Model type:
AVL62KW

Commercial code:
F033685

Notices

Fig . 001

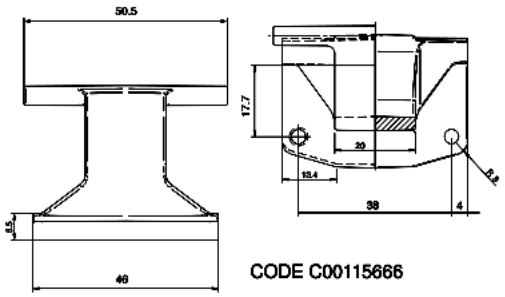
n1040349: Introduction of 150° Zamac hinge on Ariston 46 models.

From serial no. 50207.0001, all Ariston models produced in the Teverola factory (see table 001 attached) with industrial code (given on the rating plate) starting with 46, have been equipped with a Zamac hinge with 150° opening angle, code C00115666 (see Fig.001).
This modification has involved the introduction of the following items:

Code C00115670 - Complete door EVOII 150° white 27 with standard glass;
Code C00115674 - Complete door EVOII 150° white 27 with long glass;
Code C00115667 - EVOII body for 150° hinge white 27;

The premodified items are not interchangeable separately with the modified ones.

Code C00110133 - Complete door EVOII Standard 180° white 27 standard glass;
Code C00092157 - Complete door EVOII 180° white 27 long glass;
Code C00096193 - EVOII body for 150° hinge white 27;

The hinge code C00064541 continues to be used on the build-under models produced in the Comunanza factory.
